T-117

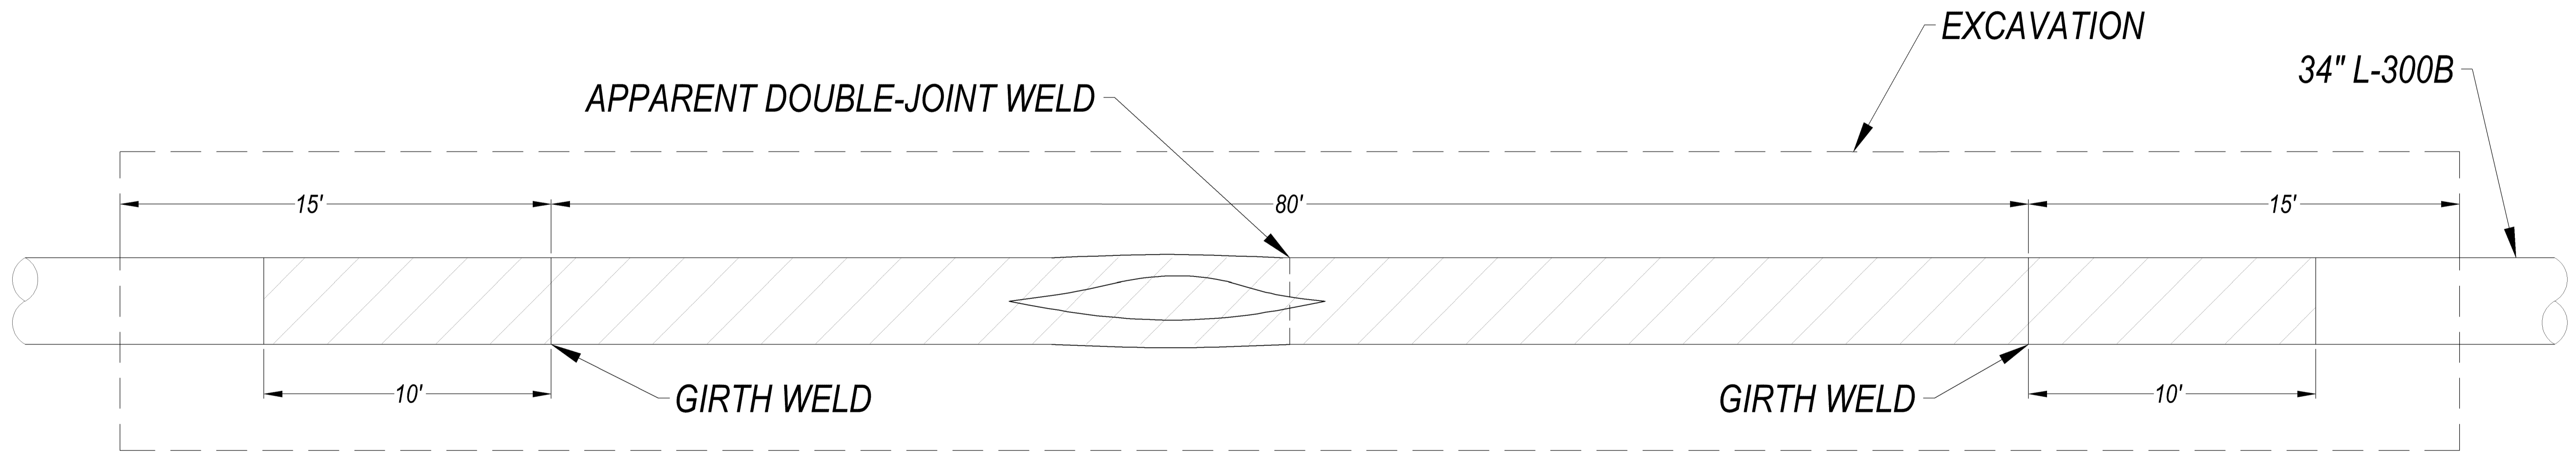
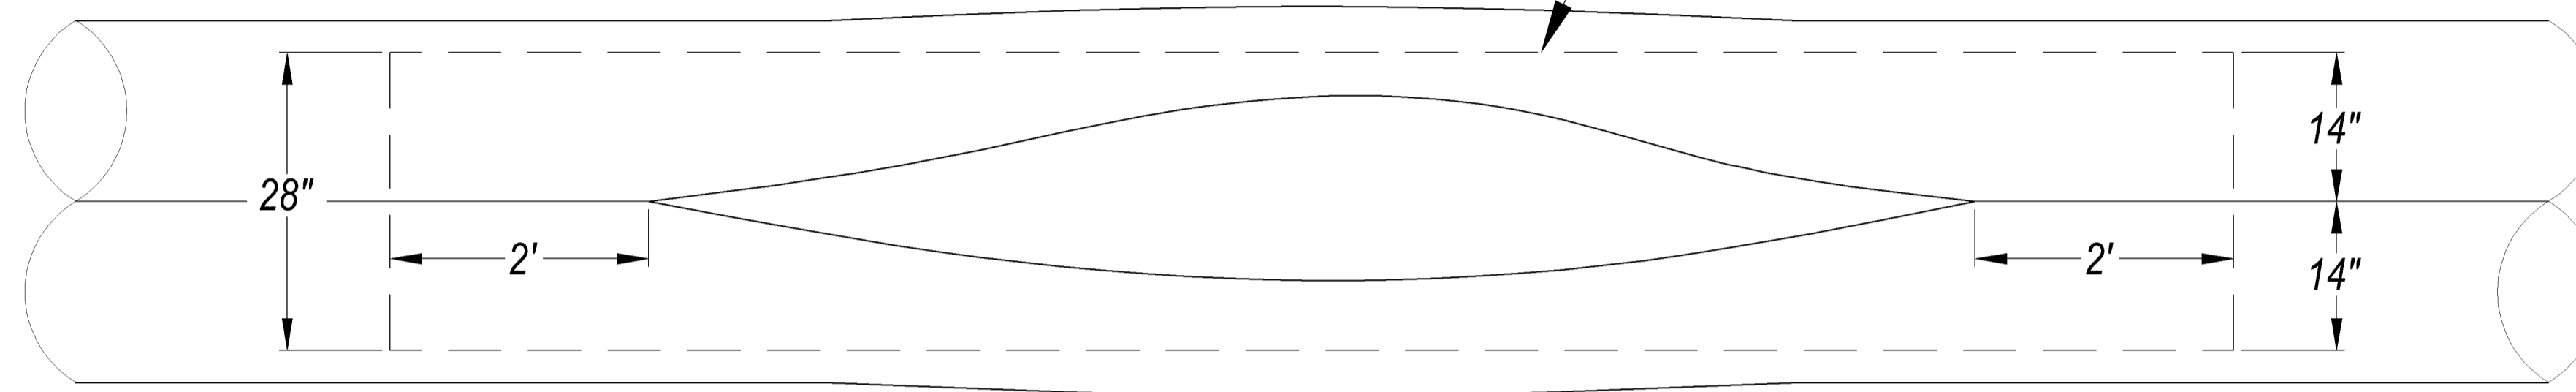
CUT OUT QUADRANT CONTAINING FAILURE
(CENTERED IN CUT-OUT) FROM 2' BEYOND
EXTENT OF FAILURE EACH WAY

= REPLACE WITH 34.00"OD x 0.375"WT,
API 5L, X-65 PIPE (M011067)
